PUBLIC WORKS DEPARTMENT
ENGINEERING DIVISION
156 S. BROADWAY, SUITE 150
TURLOCK, CA 95380

City Project No.: 23-040

Addendum No.: 1

PROJECT TITLE: Water Line Replacement for 2024 Roads Program Construction

EXHIBIT A - PROPOSED STORM DRAIN SYSTEM

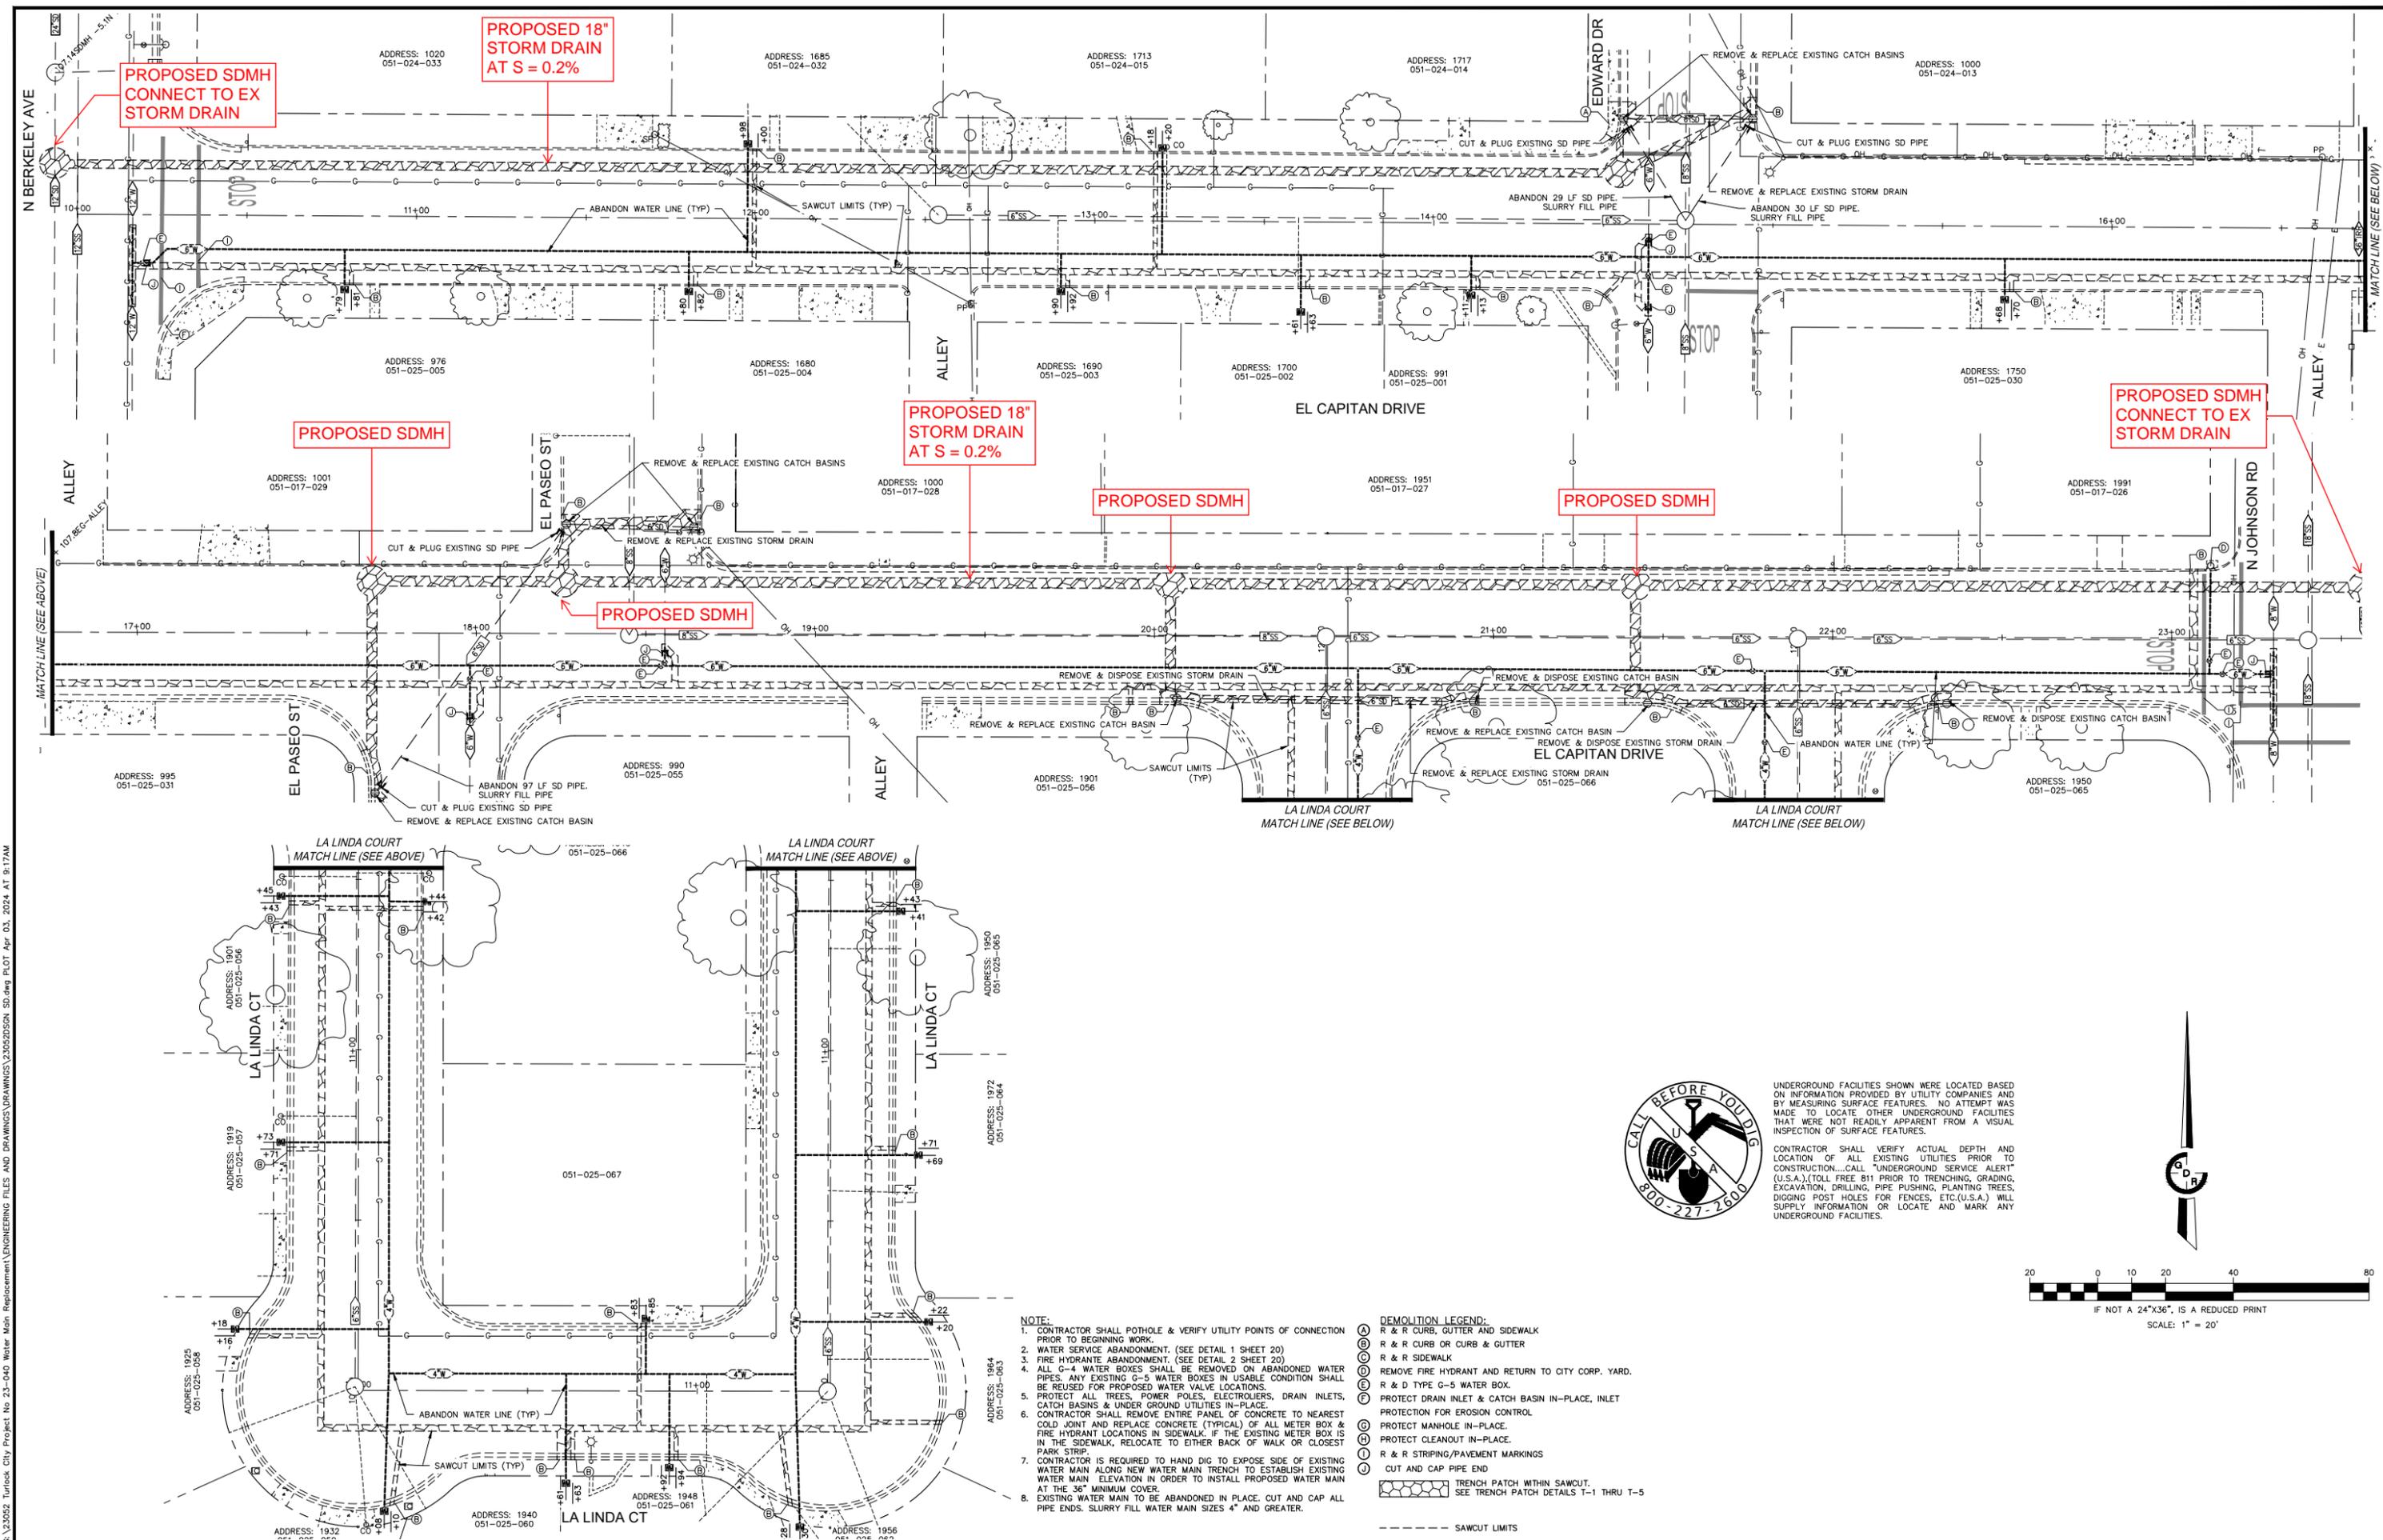
Item No. 2 – Reference the attached Exhibit A – Proposed Storm Drain System for details regarding the proposed storm lines, manholes, and more. Revised drawings to be issued next week.
